Subject: USNRC Docket No. 72-1014, TAC L23344
HI-STORM 100 Certificate of Compliance 1014

We have reviewed the preliminary Certificate of Compliance (CoC) and Safety Evaluation Report (SER) for our HI-STORM 100 System amendment request that was enclosed with the above-referenced letter. The two tables attached to this letter contain our comments on the CoC and SER. Table 1 contains comments on the CoC and its appendices. Table 2 contains comments on the SER.

Table 1
Holtec Comments on Preliminary CoC

Table 2
 Holtec Comments on Preliminary SER

Figure 2.A.1;
 Typical HI-STORM/ISFSI pad Fastening Detail

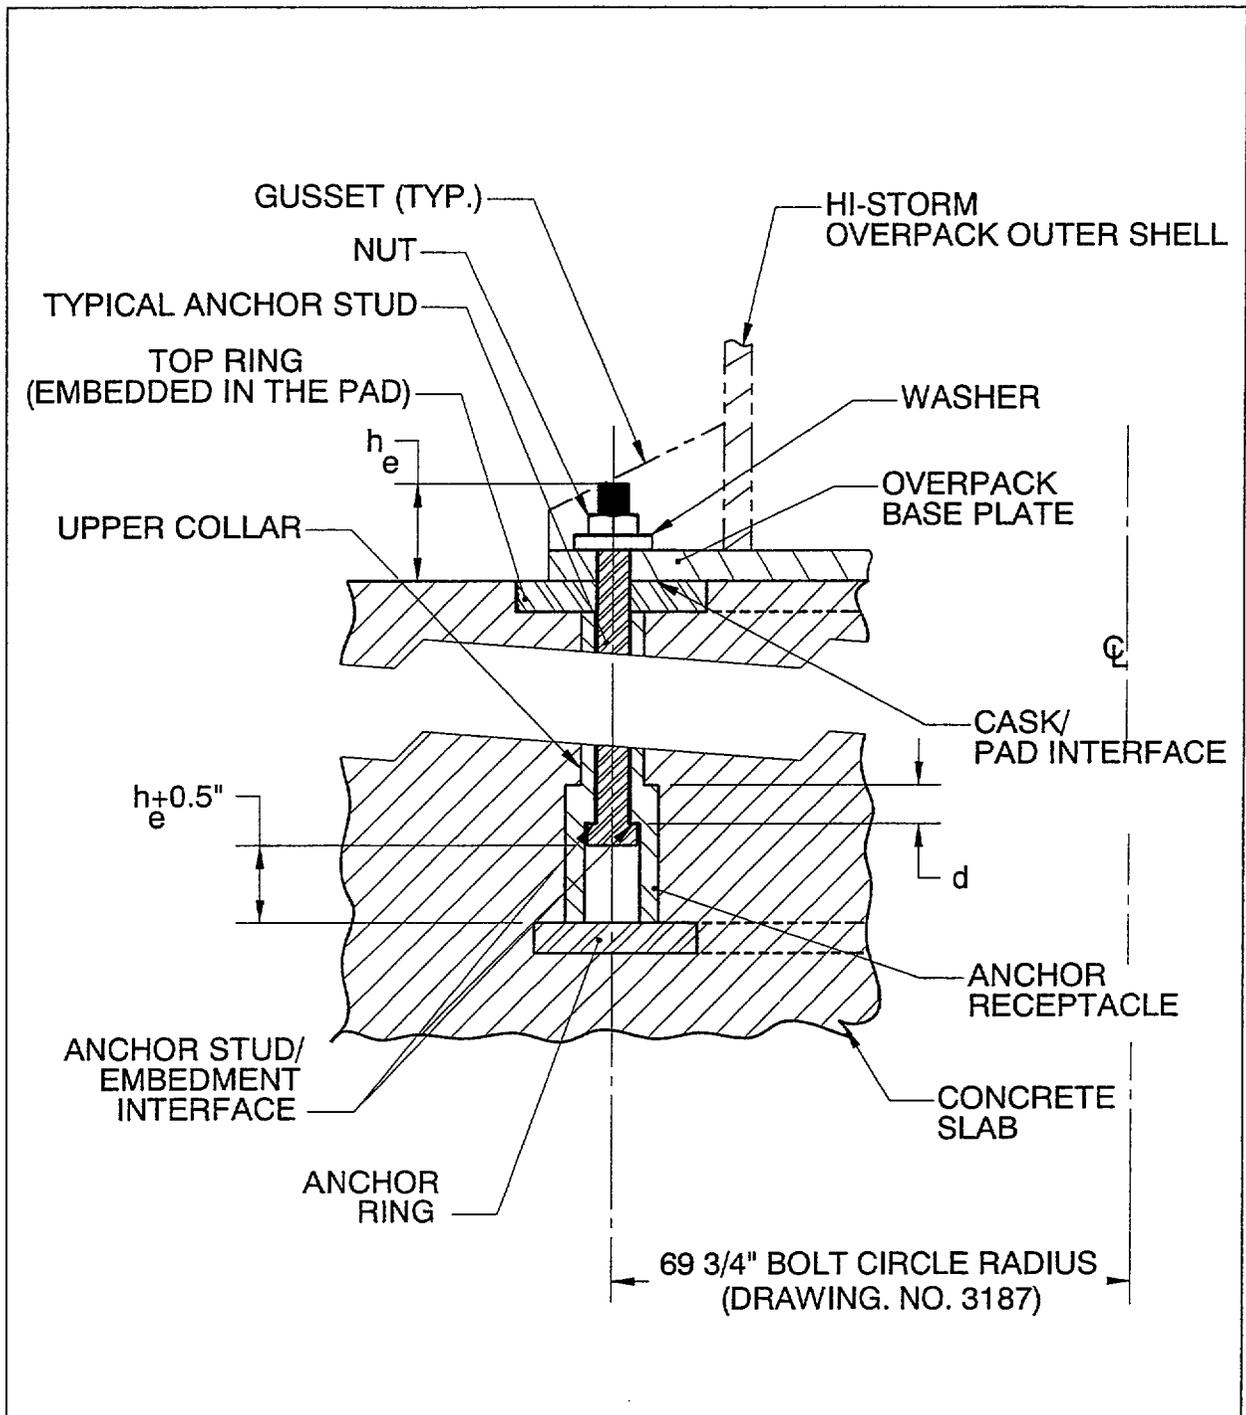
To address the comment in the last sentence of SER Section 2.1, we enclose a proposed modification to FSAR Appendix 2.A, Section 2.A.3 to better describe those components of the cask anchorage system that are important to safety. Assuming these changes address this SER comment adequately, they will be included in Revision 1 of the FSAR.

- iv. The load-bearing members of the HI-STORM 100A anchorage system shall be

considered important-to-safety. This includes the following components shown in Figure 2.A.1: anchor stud and nut, top ring, upper collar, anchor receptacle, and anchor ring.
